Product Change Notification - SYST-25MCXX581

ERRATA - dsPIC33EPXXGS202 Family Silicon Errata and Data Sheet Clarification

- 1) Adds new silicon issue 33.
- 2) This revision of the document shows changed bit representation (e.g., changed to [3:0]) to be consistent with SDL documents.

dsPIC33EPXXGS202 Family Silicon Errata and Data Sheet Clarification

FIGURE 1: EXAMPLE FOR REDUNDANT OUTPUT MODE

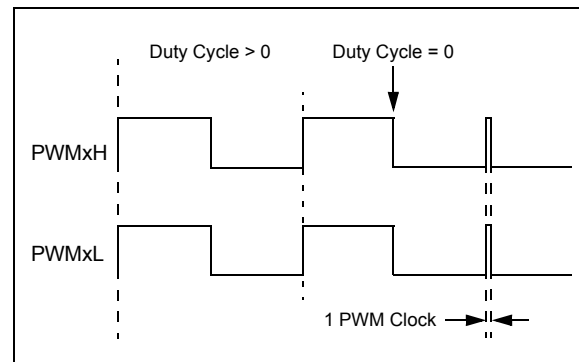
7. Module: PWM

In the Redundant Output mode (`IOCONx[11:10] = 0b01`) and Push-Pull Output mode (`IOCONx[11:10] = 0b10`), with the Immediate Update Enable bit disabled (`PWMCONx[0] = 0`), when the Duty Cycle register is updated from a non-zero value to zero, a glitch pulse of a width equal to one PWM clock will appear at the next PWM period boundary, as shown in Figure 1 (for the Redundant Output mode). The Duty Cycle register refers to the `PDCx` register if `PWMCONx[8] = 0` or the `MDC` register if `PWMCONx[8] = 1`.

If the application requires a zero duty cycle output, there are two possible work around methods:

1. Use the PWM override feature to override the PWM output to a low state instead of writing to the Duty Cycle register. In order to switch back to a non-zero duty cycle output, turn off the PWM override. The override-on and override-off events must be timed close to the PWM period boundary if the `IOCONx` register has been configured with `IOCONx[0] = 0` (i.e., output overrides through the `OVDDAT[1:0]` bits occur on the next CPU clock boundary).
2. Enable the Immediate Update Enable bit (`PWMCONx[0] = 1`) while configuring the PWMx module (i.e., before enabling the PWMx module, `PTCON[15] = 1`). With the Immediate Update enabled, writes to the Duty Cycle register can have an immediate effect on the PWM output. Therefore, the duty cycle write operations must be timed close to the PWM period boundary in order to avoid distortions in the PWM output.

FIGURE 2:

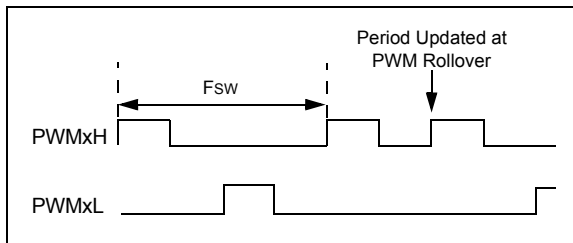
9. Module: PWM

When the PWM module is configured for Push-Pull mode (IOCONx[11:10] = 0b10) with the Enable Immediate Period Update bit enabled (PTCON[10] = 1), a write to the Period register that coincides with the period rollover event may cause the push-pull output logic to produce back-to-back pulses on the PWMx pins (Figure 2).

If the EIPU bit is set (PTCON[10] = 1), ensure that the update to the PWM Period register occurs away from the PWM rollover event. Use either the PWM Special Event Trigger (SEVTCMP) or the PWM Primary Trigger (TRIGx) to generate a PWM Interrupt Service Routine (ISR) near the start of the PWM cycle. The PWM Period register could be updated inside this ISR so that the period writes do not occur near the PWM period rollover event.

FIGURE 3: MISMATCH OF WORKING REGISTER SET WHEN NESTING MORE THAN ONE INTERRUPT WITHIN INTERRUPTS THAT USE ALTERNATE WORKING REGISTER SETS

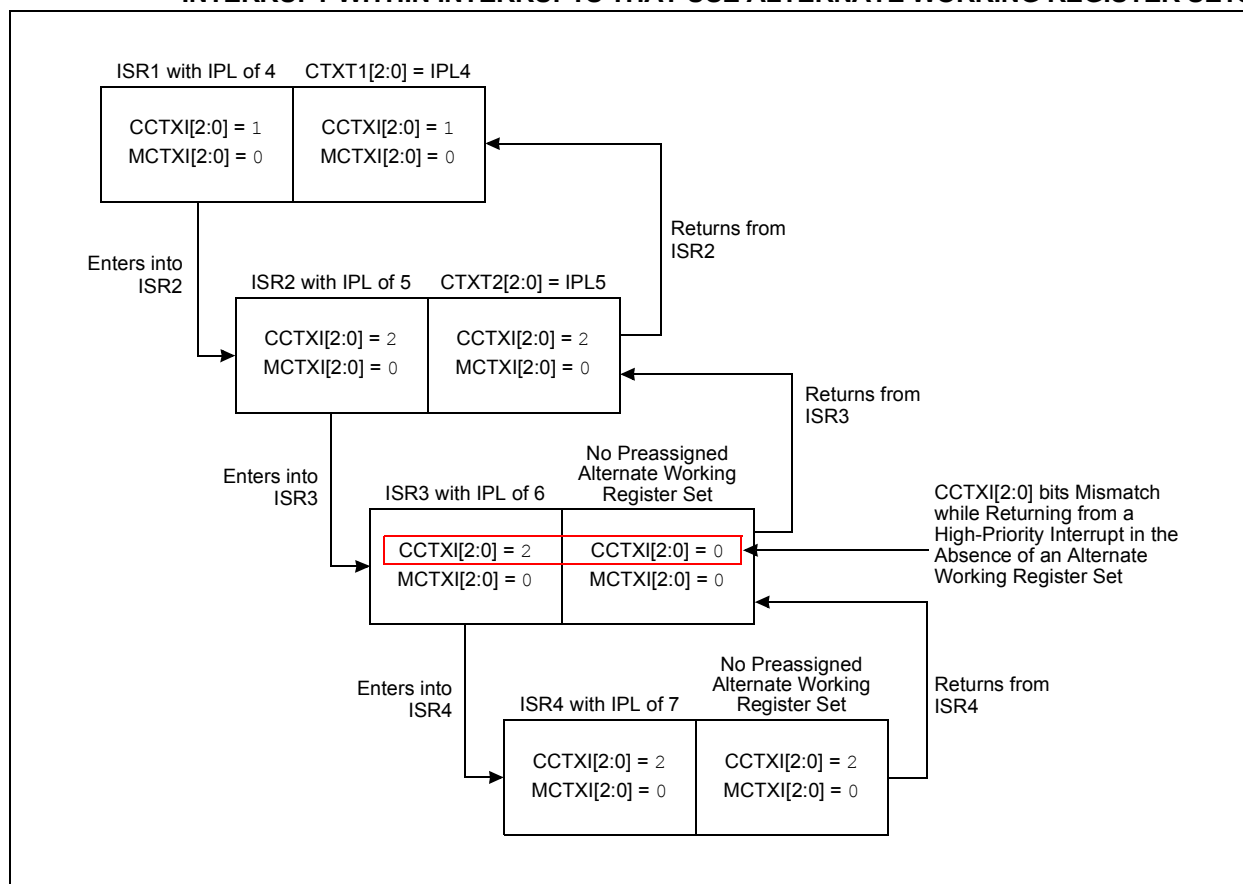
When returning from an Interrupt Service Routine (ISR) by executing the `RETFIE` instruction, in the case of a nested interrupt, the Interrupt Priority bits (`IPC[3:0]`) associated with the lower priority interrupt are compared with the `CTXTn` bits field in the `FLTREG` Configuration register:

When using interrupts with the Alternate Working Register Set (automatic context assignment), no more than one ISR without an Alternate Working Register Set must be nested within an ISR with an Alternate Working Register Set.

Issue and work around are illustrated in [Figure 3](#) and [Figure 4](#), respectively. The figures show the status bits, `CCTXI[2:0]` and `MCTXI[2:0]`, after entering into an ISR from a lower priority ISR (left pane), and after returning to the same ISR from a higher priority ISR (right pane).

FIGURE 5: SIMPLIFIED BEHAVIOR

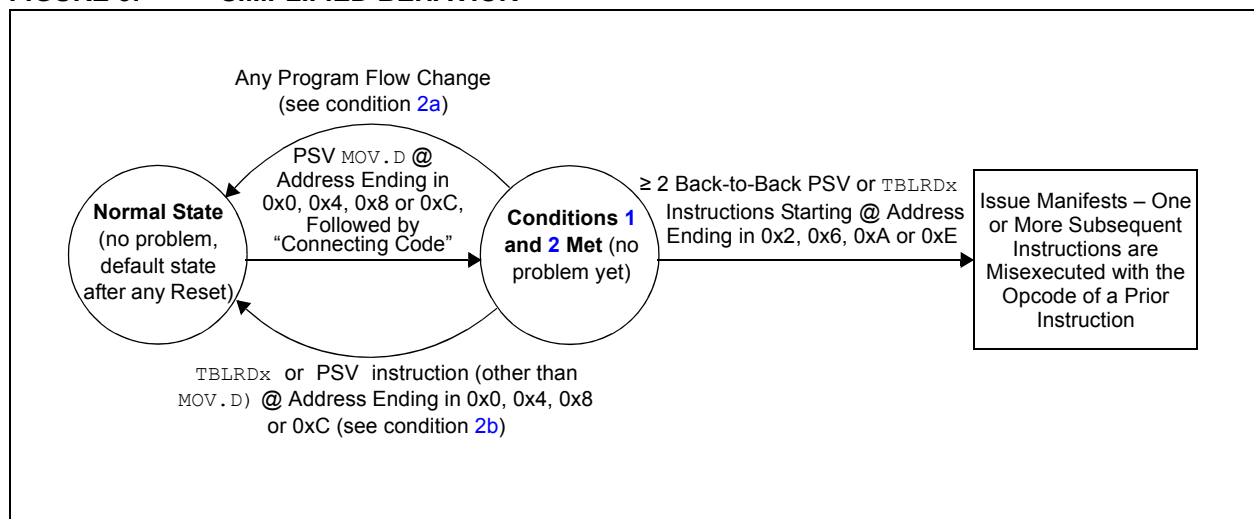
When two or more data Flash read instructions (via Program Space Visibility (PSV) read or table read) are executed back-to-back, one or more subsequent instructions can be misexecuted when all of the conditions in [Table 4](#) occur.

[Figure 5](#) provides an example of the effective behavior.

The issue can be avoided by ensuring any one or more of the requirements are not met. For example:

1. All instances of PSV `MOV.D` can be replaced with two PSV `MOV` instructions instead. Non-PSV `MOV.D` instructions acting on RAM/SFRs do not need to be modified; or
2. If not already present, a program flow change instruction (such as `BRA $+2`) can be inserted above back-to-back data Flash read sequences; or
3. Back-to-back data Flash read instruction sequences can be broken up by inserting a non-Flash read instruction (such as a `NOP`), in between the Flash read instructions; or
4. The alignment of the code can be shifted to avoid the required opcode location addresses.
